Access Compliance Report Public Rights-of-Way (Curb Ramps)

Main Street: BIRD_RD Cross Street: RIATA_ST Location: SE

ADA ID: RPRK220203123856 Ramp Type: Type 4 - Parallel Initial Pass/Fail: Fail Overall Compliance: No Severity Score: 2

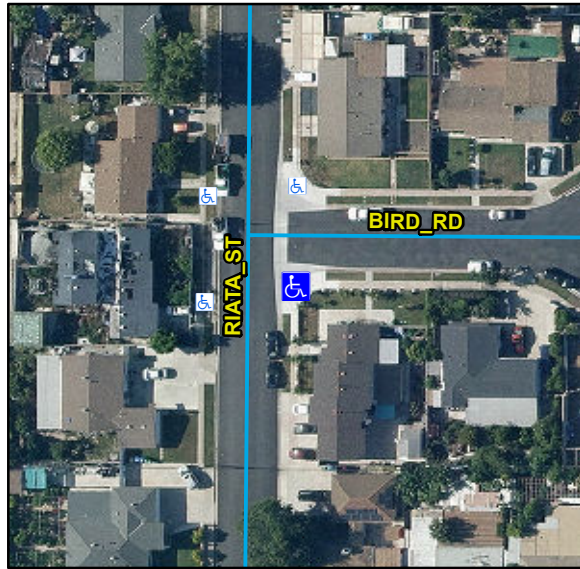
Compliance	Description	Data	Compliance	Description	Data
N/A	Ramp Length LT (in)	73	N/A	Ramp Length RT (in)	73
Yes	Ramp Width LT (in)	114	Yes	Ramp Width RT (in)	114
Yes	Ramp Run Slope LT (%)	7.4	Yes	Ramp Run Slope RT (%)	6.2
No	Ramp Cross Slope LT (%)	2.7	No	Ramp Cross Slope RT (%)	3.6
N/A	Landing Present	N/A	N/A	DWS Provided	N/A
N/A	Landing Length (in)	N/A	N/A	DWS Contrast	N/A
N/A	Landing Width (in)	N/A	N/A	DWS Length (in)	N/A
N/A	Landing Run Slope (%)	N/A	N/A	DWS Full Width	N/A
N/A	Landing Cross Slope (%)	N/A		DWS Offset Type	N/A
N/A	Landing Movement Obstructed?	N/A	N/A	DWS Offset Left (in)	N/A
	Landing Movement Type	N/A	N/A	DWS Offset Right (in)	N/A
N/A	Landing Shared	N/A			
N/A	Clear Space	Yes			
N/A	Clear Space To Crosswalk (in)	N/A			
N/A	Marked Crosswalk 1	No	N/A	Marked Crosswalk 2	No
	Crossing 1 Direction	N		Crossing 2 Direction	W
	Marked Crosswalk 1 Width (in)	N/A		Marked Crosswalk 2 Width (in)	N/A

Remove & Replace Curb Ramp With Two New Directional Ramps or Equivalent.

R304.5.3, STD 1115
